SIB 61 22 23

RECALL 23V-644: WIPER LINKAGE

This Service Information Bulletin (Revision 02) replaces SI B61 22 23 dated **September 2023**.

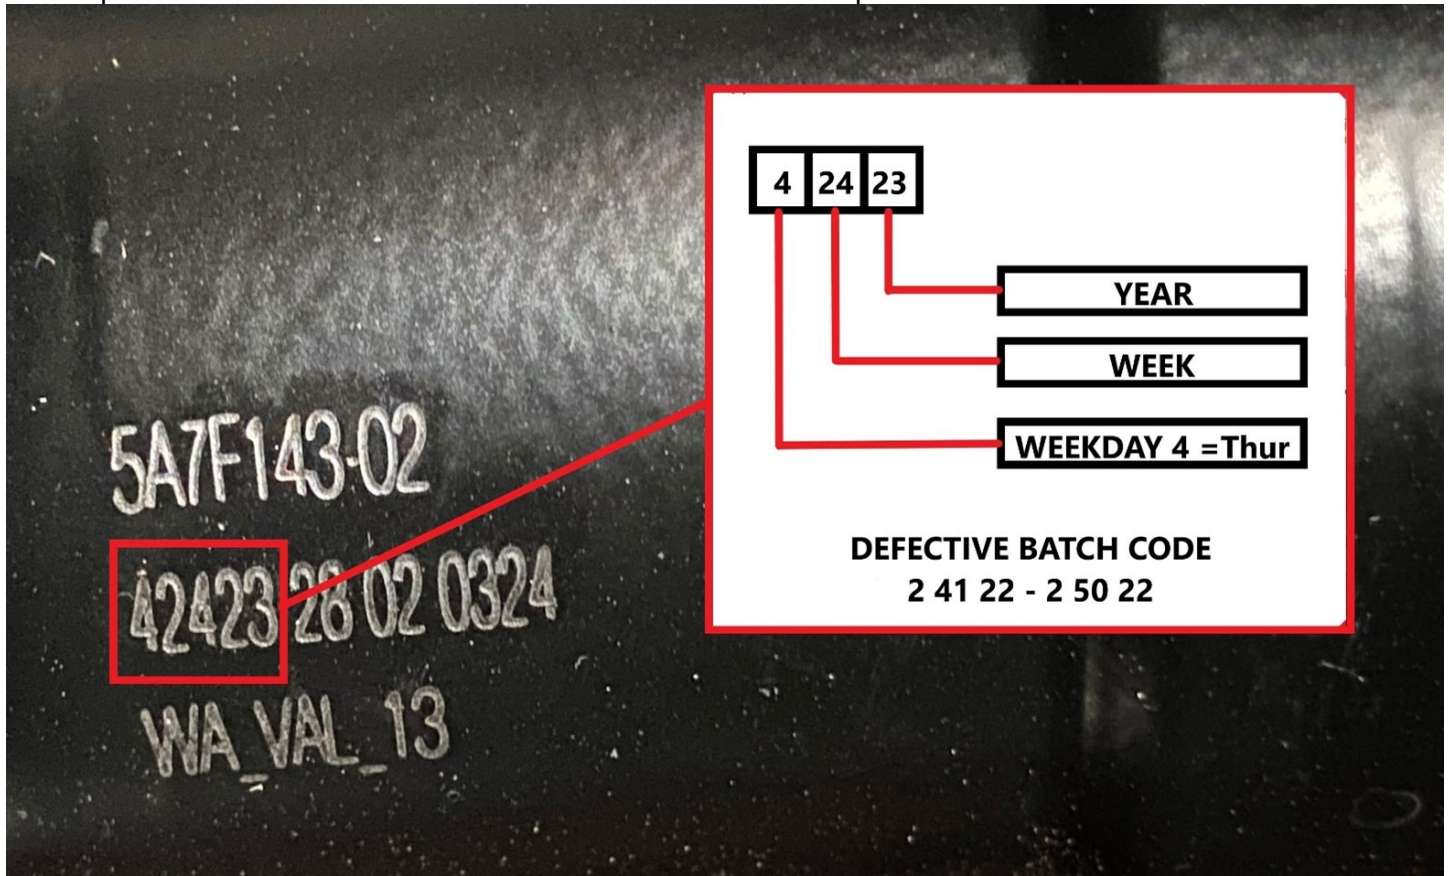
1. Remove the cover of the engine compartment at the rear left (driver side).
 2. If available, utilize a borescope device to inspect and record the wiper motor batch code; then proceed to step 6.
 3. If a borescope is not available, please proceed to step 4.

6. Compare the defective batch code and dates of the installed wiper motor.

7. When the batch code falls under the affected dates (from **2 41 22** to **2 50 22**), the wiper linkage must be replaced. Refer to repair instructions **“Replace the console for the windshield wiper system 61 61 271 | REP-REP-P-6161271-G70 - V.3”** available with ISTA 4.40.5X.
